# MULTISPECTRAL SOLUTIONS, INC.

In the Matter of }  
 }  
Revision of Part 15 of the Commission's }  
Rules Regarding Ultra-Wideband } ET Docket No. 98-153  
Transmission Systems }

**PETITION FOR RECONSIDERATION**

Figure 1. Inconsistencies between FCC re-interpretation of §15.35 and UWB R&O.

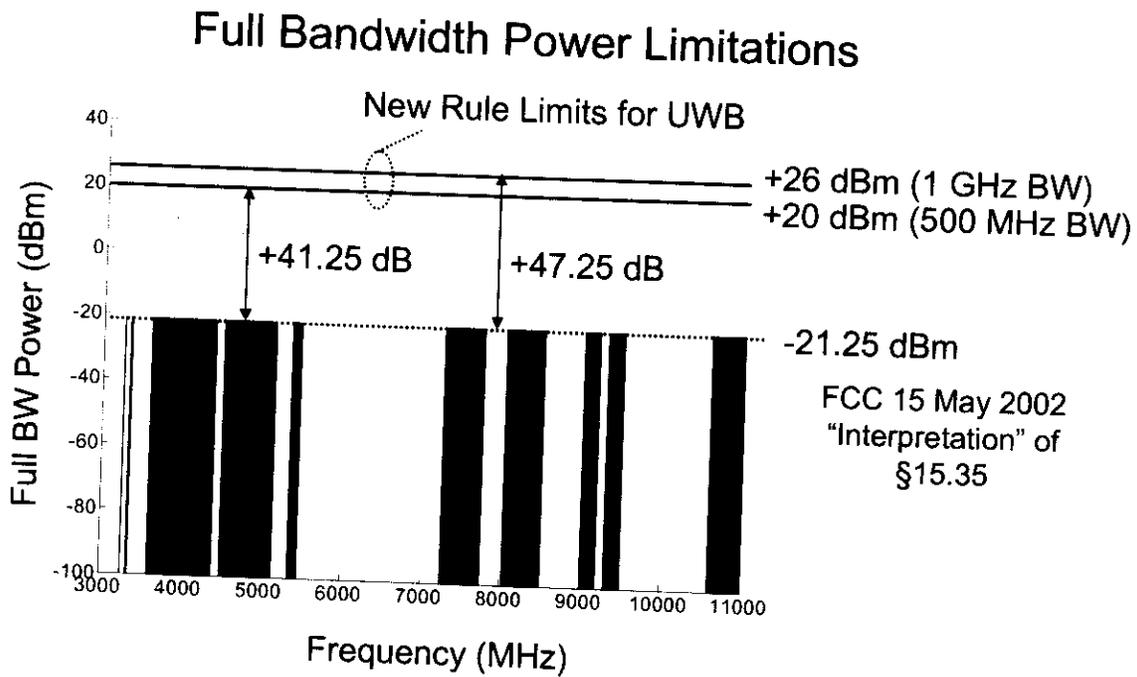
Figure 1 graphically illustrates the problem with FCC's 15 May 2002 re-interpretation of §15.35.

Thus, if pulse desensitization correction is required above 1 GHz, then UWB emissions under the new Subpart F would be a *minimum* of 41.25 dB or ***13,335 TIMES HIGHER THAN EXISTING PART 15 LIMITS WITH THESE HIGHER EMISSIONS NOW OCCURRING IN PREVIOUSLY RESTRICTED BANDS.*** There is not a single comment relating to this issue in the entire UWB proceeding; nor do the FCC's briefing charts on the UWB R&O reflect this interpretation. Concerned spectrum users will indeed be shocked to learn what the actual approved UWB power levels represent. Thus, it must be concluded that the FCC's new "interpretation" of the existing law (i.e., §15.35 and §15.209) is inconsistent with the present UWB First Report and Order.

If the FCC now believes that pulse desensitization correction is required *above* 1 GHz, and that -21.25 dBm was the previous Part 15 limit on *full bandwidth peak power*; then the peak power limit of 0 dBm/50 MHz as specified in the UWB First Report and Order is a minimum of 41.25 dB *higher* than that specified in Part 15. To be consistent with Part 15 and the vast record in this proceeding, the FCC must limit the *full bandwidth peak power* of UWB emissions to -21.25 dBm, for there is no discussion in this docket of permitting emission levels (whether peak or average) higher than existing Part 15.

If the FCC wishes to retain the limitation of 0 dBm/50 MHz for UWB emissions as stated in the UWB First Report and Order; then it is imperative that the FCC correctly interpret §15.35(b) as not requiring pulse desensitization correction above 1 GHz. To clarify this issue, the FCC should modify §15.35(b) in the current First R&O to explicitly state this fact. Note that this interpretation would still maintain a limit on peak emissions (i.e., no greater than 20 dB above the maximum average emission), but would measure such emissions appropriately as *peak spectral density* as originally intended in the vast record of documents and testimony related to §15.35.

Figure 1. FCC Spectrum Mask for Indoor Communications Systems.

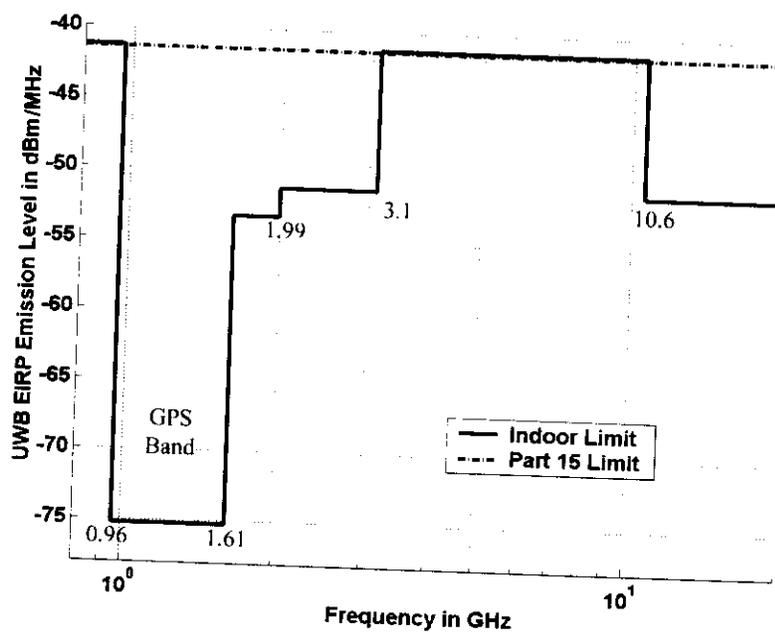
Note that, in all cases, only a single limit (500  $\mu\text{V}/\text{m}$ , or -41.25 dBm/MHz) was specified below 960 MHz.

However, this is inconsistent with the R&O wherein it is stated [e.g., §15.509(d), §15.511(d), §15.513(d), §15.515(d), §15.517(c) and §15.519(c)] that

Thus, for example, in the frequency range 216 to 960 MHz, §15.209(a) specifies that the emissions must be 8.0 dB *lower* than as specified in the Subpart F FCC spectrum masks. In the 30 to 88 MHz portion of the spectrum, emissions must be 14.0 dB *lower*.

While it may have been the FCC's intent to increase §15.209(a) general emission limits below 960 MHz, nothing in the record has been provided to support this increase. Thus, the FCC should clarify that the charts provided by OET do not correctly reflect the wording of Subpart F. To prevent confusion, it is recommended that the FCC explicitly include the above table in Subpart F.
